ALERT SERVICE BULLETIN
Bell Helicopter **TEXTRON**

NO. 230-07-36

MODEL AFFECTED: 230

SUBJECT: TAIL ROTOR PITCH CHANGE MECHANISM,
REVISED RIGGING PROCEDURES

Figure 1. Tail Rotor Pitch Change Mechanism (Position)

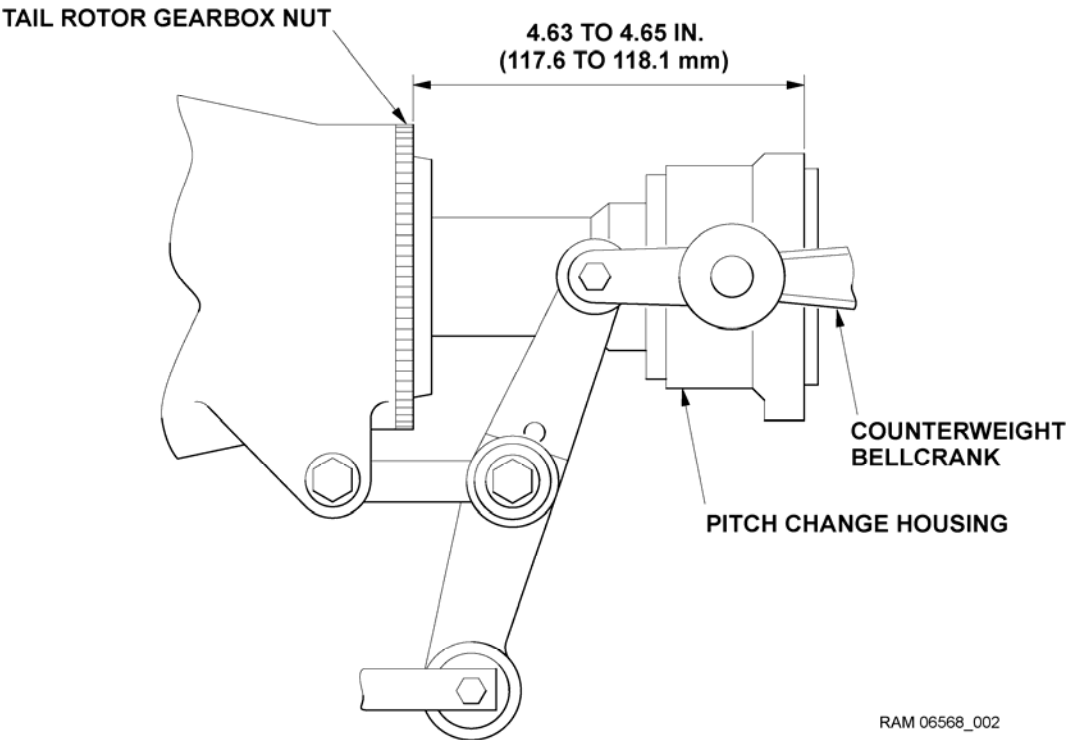
1. Move the tail rotor pedals as required and set the pitch change housing to obtain a 4.63 to 4.65 inches (117.6 to 118.1 mm) dimension as shown in Figure 1. Maintain this position.

There is no maximum limit on the gap that may exist between the tail rotor yoke and nut (4) when the pitch change housing is positioned as shown in figure 1 and the counterweight bellcranks (12) are parallel to the tail rotor gearbox output shaft.

Adjusting nut (4) and nut (8) to obtain a 0.020 to 0.030 inch (0.50 to 0.76 mm) gap between the tail rotor yoke and nut (4) will result in a minor misalignment of the counterweight bellcranks (12) in relation to the tail rotor gearbox output shaft. A maximum misalignment of 1.6 degrees of the counterweight bellcranks (12) in relation to the tail rotor gearbox output shaft is acceptable when the pitch change housing is positioned as shown in figure 1.

Do not adjust nut (4) and nut (8) to obtain a gap of more than 0.030 inch (0.76 mm) between the tail rotor yoke and nut (4). This will result in misalignment of the counterweight bellcranks (12) beyond the permissible maximum limit of 1.6 degrees (in relation to the tail rotor gearbox output shaft) when the pitch change housing is positioned as shown in figure 1. This is NOT acceptable.

Figure 2. Tail Rotor Pitch Change Mechanism

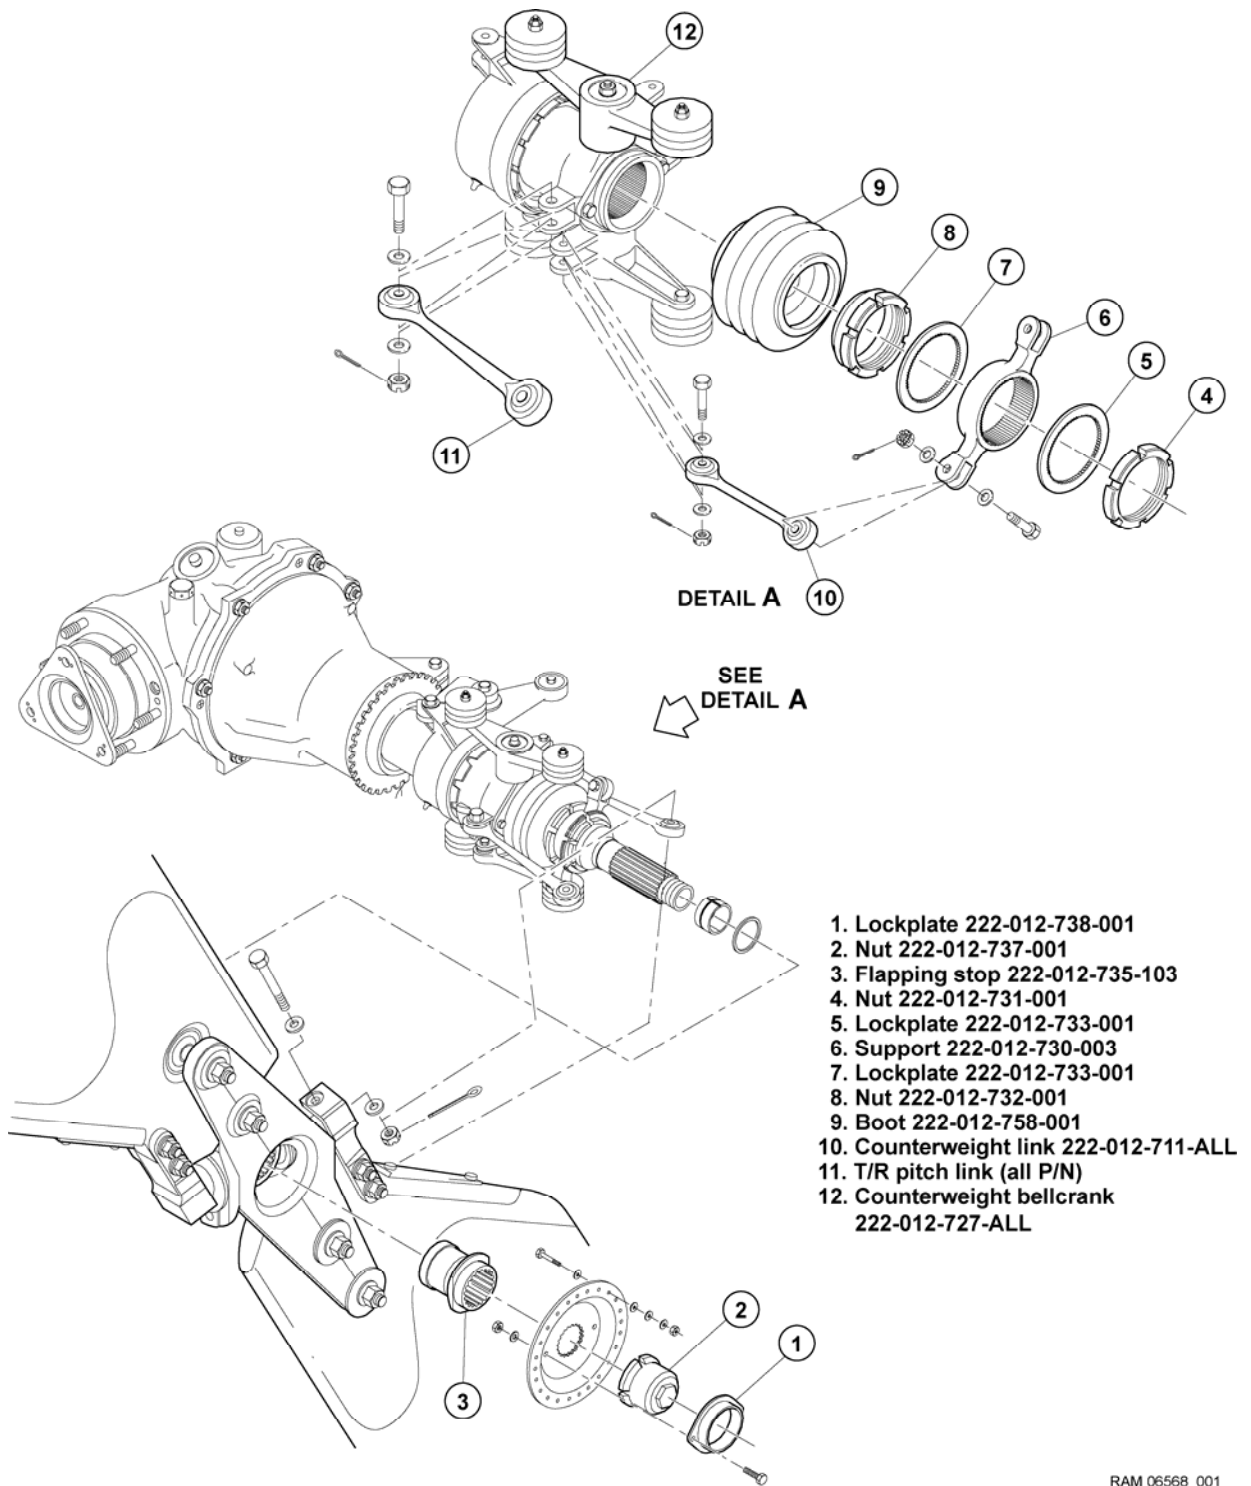
2. Verify that the centerline of counterweight bellcranks, (12, Figure 2) are parallel with the centerline of the tail rotor gearbox output shaft. If the counterweight bellcranks (12) are parallel with the centerline of the tail rotor gearbox output shaft, proceed to step 3. If the counterweight bellcranks (12) are not parallel with the centerline of the tail rotor gearbox output shaft, disconnect boot (9), pitch links (11) and counterweight links (10) as required. Straighten the bent edges of the lockplates (5 and 7) and adjust nut (4) and nut (8) to reposition support (6) until the counterweight bellcranks are parallel with the centerline of the tail rotor gearbox output shaft. Hold the nut (8) in position and torque the nut (4) to 50 to 55 foot-pounds (68 to 75 Nm). Do not bend the edge of the lockplates (5 and 7) into the slots of nut (4 and 8) at this time.

3. Move the tail rotor assembly through the full flap range (verify at both full flap positions). Verify if the tail rotor yoke touches the flapping stop (3) before it touches nut (4). If a gap exists between the tail rotor yoke and the flapping stop (3), replace the existing tail rotor yoke with yoke P/N 222-012-702-117. Notify BHT Product Support Engineering if yoke replacement is required.

4. If there is no gap between the flapping stop (3) and the tail rotor yoke, verify if a 0.020 inch (0.50 mm) wire type feeler gauge can be inserted between the tail rotor yoke and nut (4). If the smallest gap between the tail rotor yoke and nut (4) is 0.020 inch (0.50 mm) or more, bend the edge of the lockplates (5 and 7) into the slots of nut (4 and 8). Connect boot (9), pitch links (11) and counterweight links (10) as required and proceed to step 6.

5. If the gap between the tail rotor yoke and nut (4) measures between 0.000 and 0.019 inch (0 to 0.48 mm), adjust nut (4) and nut (8) until a gap of 0.020 to 0.030 inch (0.50 to 0.76 mm) maximum exists between the tail rotor yoke and nut (4). Hold the nut (8) in position and torque the nut (4) to 50 to 55 foot-pounds (68 to 75 Nm). Bend the edge of the lockplates (5 and 7) into the slots of the nut (4) and nut (8). Connect boot (9), pitch links (11) and counterweight links (10) as required.
6. Examine and adjust the tail rotor pedal forces if any adjustments were carried out to support (6). Refer to BHT-230-MM-7, chapter 64-00-00.
7. Annotate helicopter records to reflect compliance with this bulletin.
8. Insert the BHT-230-MM-7 Revision 14, dated 15 Dec. 2006 into the BHT-230-MM-7 manual.
